CITY OF ALBUQUERQUE

June 28, 2023

RE: 1411 Coal Ave. SW Grading and Drainage Plan (Tierra West) Engineer's Stamp Date: 1/15/2014 (K13D050A) Pad Certification Date: 06/2022 Hydrology File: K13D053

| | | Attention | | | | | |
|---|--|---------------------------------------|--|--|--|--|--|
| | GRADING AND GRAINAGE PLAN | | | | | | |

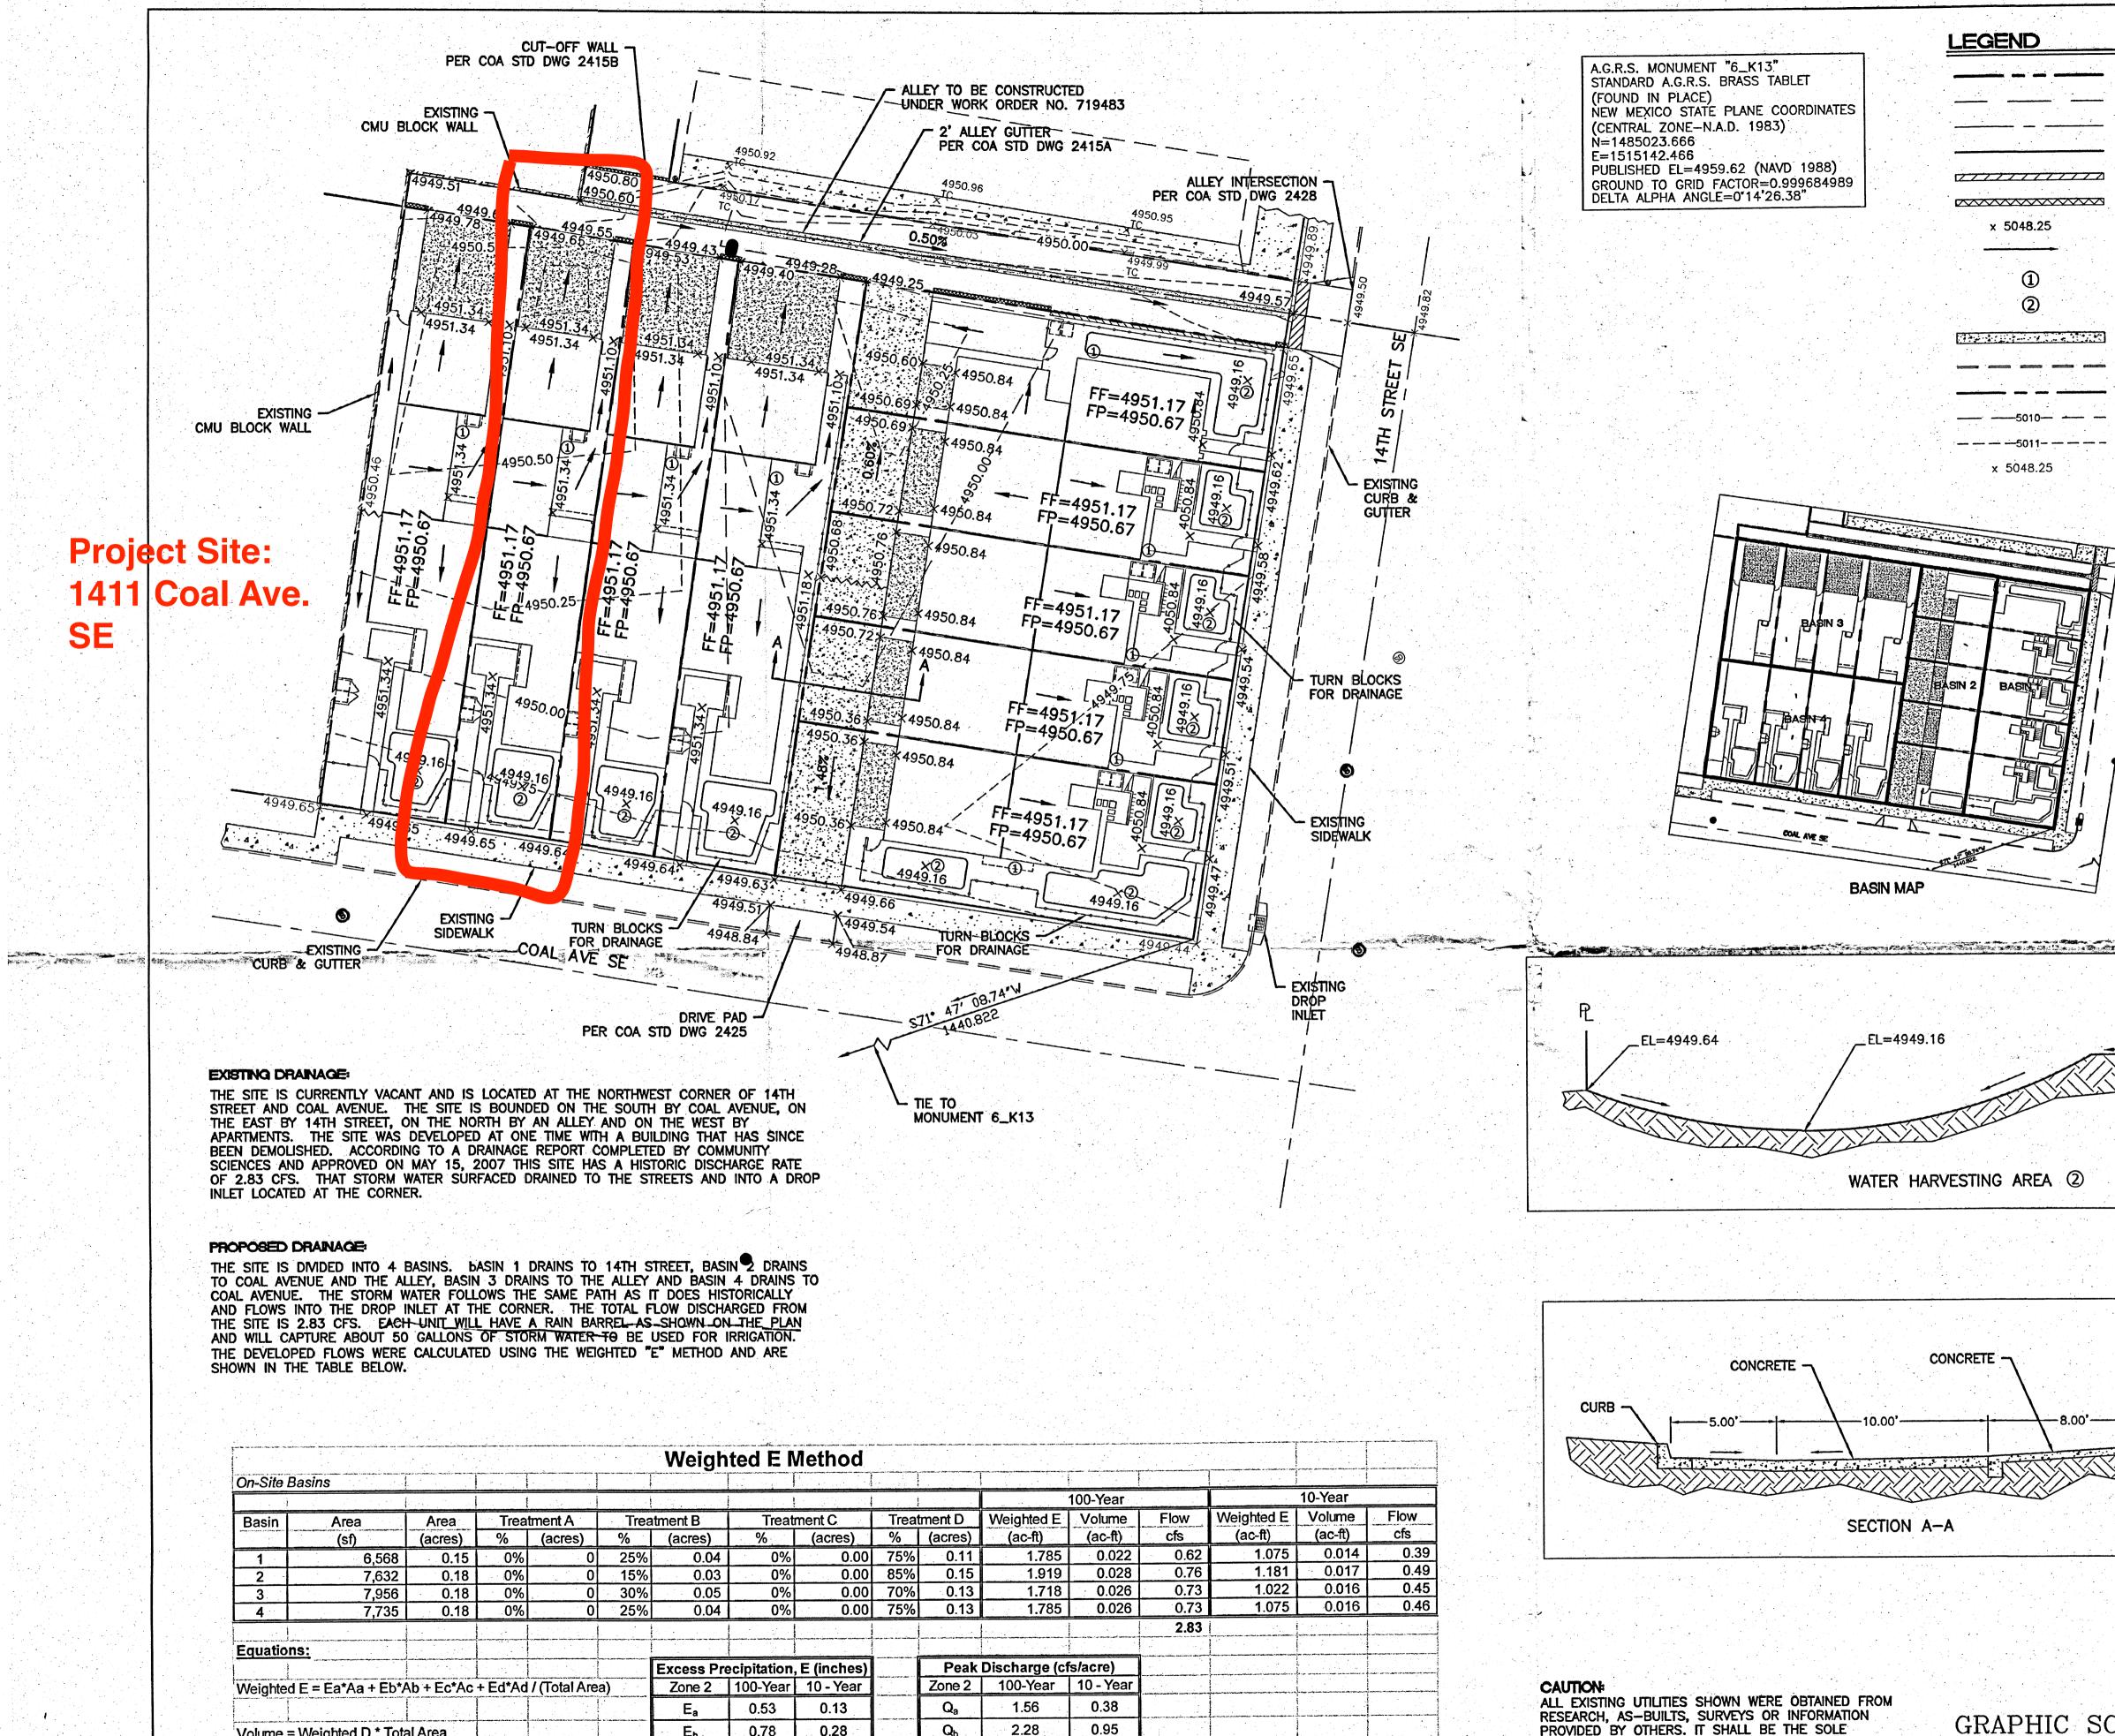
PO Box 1293 Based upon the information provided in your submittal received 06/23/2023 and previously approved Grading & Drainage Plan by Tierra West, this plan is approved for Building Permit and Building Pad Certification for **1411 Coal Ave. SW**. Please attach a copy of the Tierra West Grading & Drainage Plan in the construction sets for Building Permit processing along with a copy of this letter.

1. The site needs to ensure that it follows the Tierra West approved Grading & Drainage Plan.

2. A licensed New Mexico civil engineer will need to submit to Hydrology an Engineer's Certification, per the DPM Part 6-14 (G): Engineer's Certification Checklist for Subdivision and Part 6-14 (H): Required Certification Language is required.
